STAFF REPORT

SUBJECT: H-2021-0030
 Popeye’s Drive-Through – CUP

Conditional Use Permit for a drive-through establishment within 300-feet of an existing drive-through on 1.0 acres of land in the C-G zoning district with concurrent Administrative Design Review for the proposed building elevations.

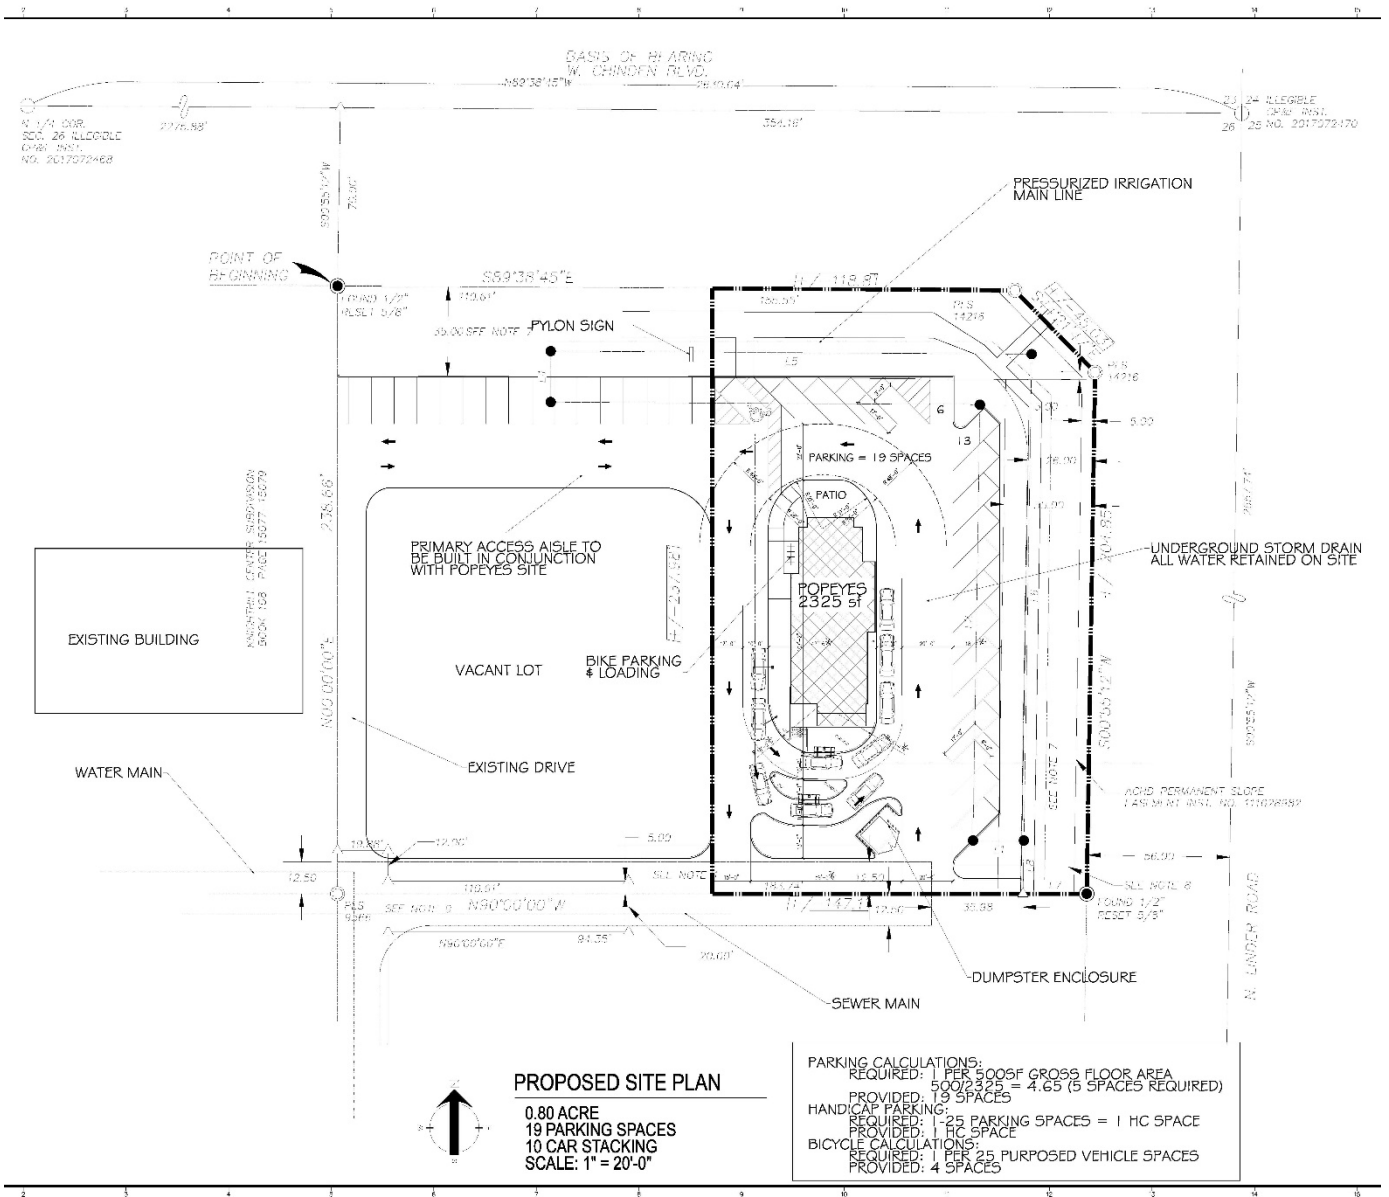
Building Elevations: The Applicant applied for Design Review concurrently with this CUP application and therefore provided building elevations to be reviewed. The building elevations were submitted as shown in Section VII.C and incorporate two main field materials, fiber cement siding and stone. The siding and stone are two contrasting colors (coal-like color and white, respectively) which adds to the overall modern design of the building. On the east and west elevations, the number of proposed windows can act as either an accent material or a third field material. The lack of modulation along the north and south elevations are of concern to Staff. In order to meet the modulation requirements for these two façades, a column of stone at least 6 inches in depth should be added to each façade, matching the overall aesthetic by placing them as evenly as possible on each façade.

The detached drive-through canopy is shown with the same two field materials (fiber cement siding and stone) as the main building and meets all of the applicable design standards outlined in the Architectural Standards Manual.

No elevations were submitted that show the proposed trash enclosure; this should be corrected with the future CZC submittal and should match the style of the proposed building. The submitted landscape plans do show adequate screening of the trash enclosure.

5. The elevations submitted with the Administrative Design Review (DES) application are approved with the following revisions:
 - a. Ensure the east and west elevations have qualifying modulation per standard 3.1A & 3.1B in the [Architectural Standards Manual](#). It is unclear based on the site plan whether the portions of the wall with the brick façade have the qualifying modulation. Any revisions to the elevations are required with the submittal of the certificate of zoning compliance application.

6. Submit elevations of the trash enclosure that generally matches the proposed building design.
7. Comply with the standards listed in UDC [11-4-3-11](#) – Drive-Through Establishment is required.

A. Proposed Site Plan (dated: 4/15/2021) NOT APPROVED

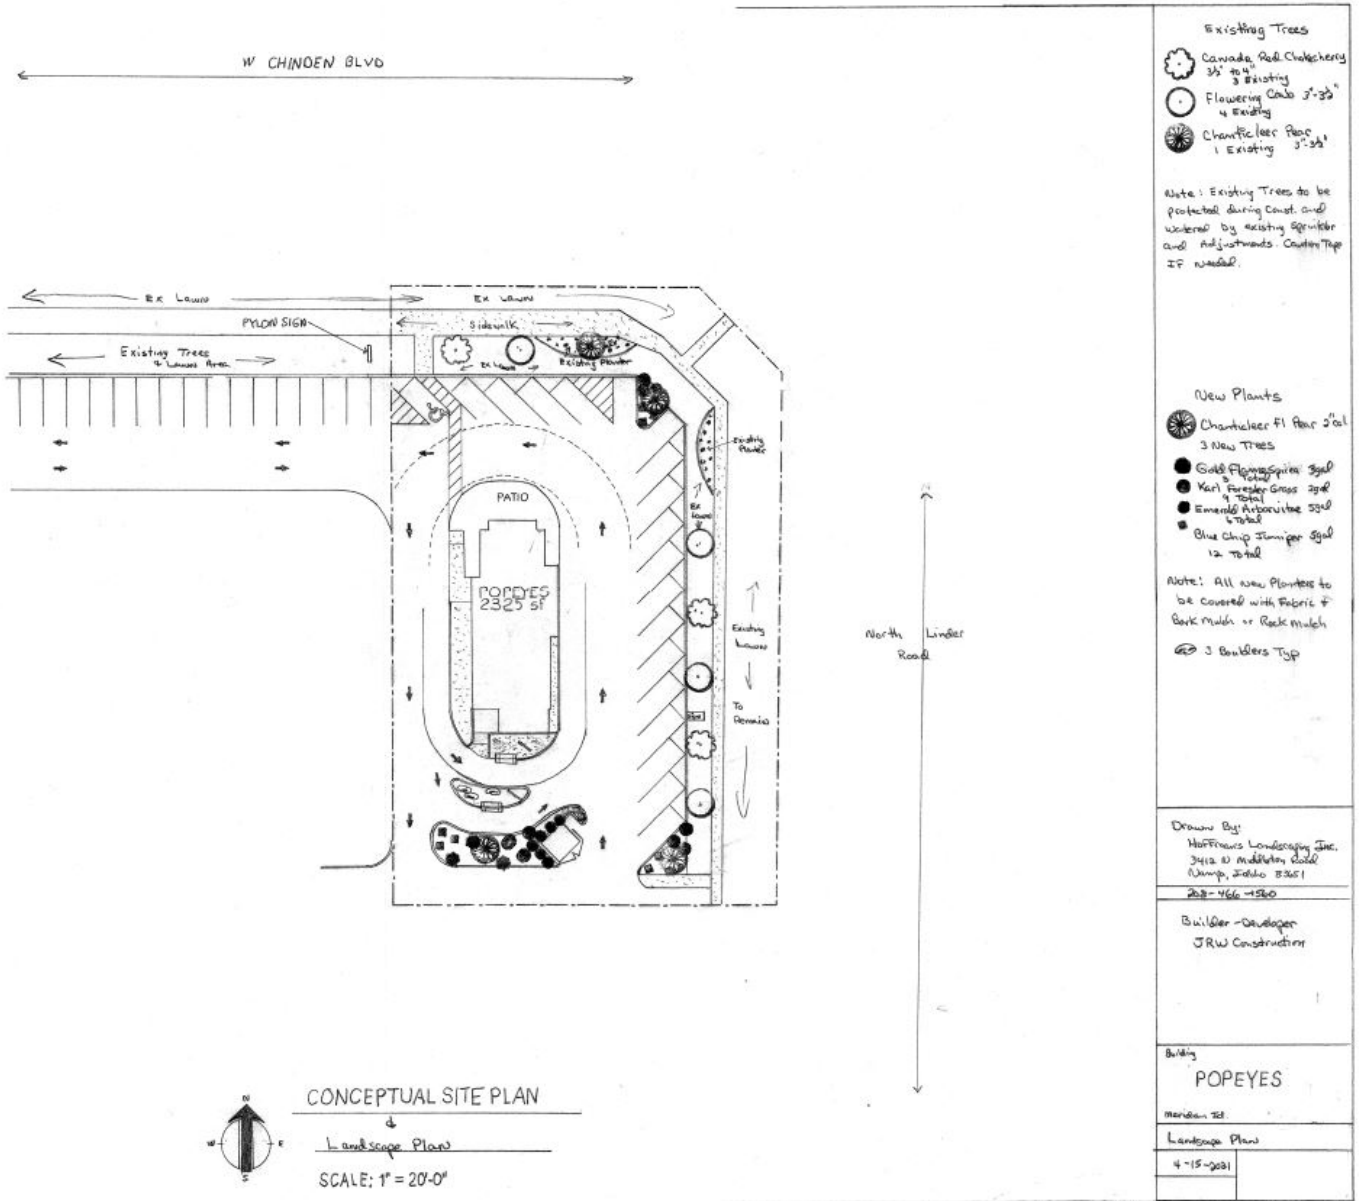
The proposed site layout places a dual ordering drive-through along the south of the site and the pick-up window on the east side of the building. With this site design the proposed drive-through has a minimal stacking lane due to the overall site and building being relatively small.

Furthermore, the site design is made for traffic to flow in a circular pattern around the building utilizing a portion of the drive aisle adjacent to the west side of the building as the stacking lane. Furthermore, the proposed site design with the anticipation of the extended north drive aisle as

the main entry point requires patrons who intend to park and utilize the dining room to go through the site along the west boundary, use the shared drive aisle along the south boundary to head east, and finally enter the site again to use the parking spaces. As proposed by the Applicant, Staff can envision patrons double stacking to order faster and block the one-way drive along the west boundary and effectively restricting patrons from using the parking spaces along the east boundary. Staff also envisions patrons blocking and/or utilizing the north drive aisle and obstructing both this anticipated exit and entry for the site with as few as seven (7) cars stacked along the west of the building (approximately 140' from the ordering window to the north drive aisle).

Per the submitted site plan, the stacking lane(s) are along the west side of the site and are separated from the west drive aisle by striping despite having two drive-through menu boards/speakers. With two proposed drive-through speakers, Staff does not find the proposed separation to be sufficient. In fact, and as noted above, Staff believes patrons would utilize the drive west drive aisle as the second stacking lane and completely obstructing this drive aisle and site exit. Staff's recommended changes above would help alleviate this issue by removing the dual drive-through speaker and placing the singular one along the north/east side of the site adjacent to the one-way drive aisle that is eight feet wider than the west drive aisle. Further analysis is below in the Access section of this report.

Access: Access to the site is shown via two drive aisles: one along the south boundary which is currently existing, and; one abutting the site in the northwest corner that is proposed to be constructed with this project. The new proposed drive aisle would traverse an undeveloped lot and connect to a drive aisle that serves existing commercial buildings along Chinden (including an additional drive-through). This drive aisle is the proposed main entry point to the site, according to the Applicant.

The south drive aisle is existing and traverses through the entire commercial subdivision with an access to a private drive aisle intended to be an auxiliary ingress/egress point for the properties in this area. Because the south drive aisle does not have any parking that directly accesses this drive aisle and has access to an auxiliary ingress/egress point, Staff believes this drive aisle will be far more utilized than the new north drive aisle that starts much closer to the Chinden ingress/egress and is essentially a parking lot instead of a drive aisle.

Consistent with Staff recommendations above, Staff recommends flipping the parking from the east side of the site to the west side of the site and face them south to further mitigate conflicts of stacking and parking. By placing the angled parking on the west side and facing them south instead of north, combined with Staff's previous recommendations of flipping the order and pick-up areas, the building can be shifted east by approximately the width of the proposed 20' drive aisle and the angled parking stalls. Therefore, the east drive aisle and south entrance could be used solely for ordering and stacking at the new location of the menu boards along the north end of the site. With the angled parking along the west side of the building, the one-way drive aisle must be at least 13 feet wide per UDC 11-3C-4 but Staff feels it should largely mirror what is currently proposed on the east side (approximately 20 feet wide) to allow for the drive aisle to function as the escape plan as discussed above. Furthermore, the flip of the site allows the escape lane and the drive-thru exit to pick-up their order and immediately exit to the south without impeding as many parking spaces. The Applicant could then designate the parking along the north drive aisle as employee parking to meet the drive-through establishment specific use standard that states employee parking may be impeded by stacking lanes (the new order and stacking location along the east and north sides of the building could impede the parking along the north boundary).

Pedestrian Walkways: A striped pedestrian walkway is depicted on the site plan from the proposed building to the multi-use pathway along W. Chinden Blvd. as required by UDC 11-3A-19B.4a. It also appears there is a sidewalk proposed near the south boundary of the site as a connection to the sidewalk along Linder Rd. However, it is not clear by the submitted plans where the sidewalk is and appears to run into the proposed trash enclosure location. *Staff's recommended changes would allow the trash enclosure to be pushed further north enough to allow for an unobstructed sidewalk along the south boundary of the site. Because it is unclear if the Applicant is proposing a sidewalk along the south boundary, Staff recommends the Applicant make it clearly visible where the pedestrian facilities are when revising the site plan; this allows the Applicant to match what is existing along the south side of the drive aisle along the south boundary of the site. In addition, this pedestrian walkway to Linder has to traverse a drive aisle and should be distinguished from the driving surface. The Applicant should also make it clear where a pedestrian connection to the Linder sidewalk is*

Furthermore, subsection B of this code section requires that the pedestrian walkway be distinguished from the driving surface by being constructed with pavers, brick, or scored/colored concrete. The proposed site plan appears to only show striping which does not comply with this code section. The Applicant should show compliance with this code section with a future CZC submittal.

3. The site plan submitted with the future Certificate of Zoning Compliance application shall be revised as follows:
 - a. Depict the pick-up window on the west side of the building and the menu board/order speaker along the north/northeast side of the building;

- b. Depict the north facing angled parking to be on the west side of the site instead of the east side of the site and angle them southbound;
 - c. Shift the proposed building to the east and to the south to allow for better utilization of the site along the north drive aisle with the option to incorporate more landscaping for screening;

- d. Designate the parking along the north boundary of the site as employee-only parking and move the handicap space to the new parking along the west boundary to place it closer to the building entrance;

- e. Depict pedestrian facilities along the south boundary of the site to match what is on the south side of this shared drive aisle; depict these pedestrian walkways and their connections clearly on revised site plans;

- f. Per UDC 11-3A-19B.4b, depict pedestrian walkways across driving surfaces to be constructed with bricks, pavers, and/or colored or scored concrete to clearly delineate the driving surface from the pedestrian walkway.
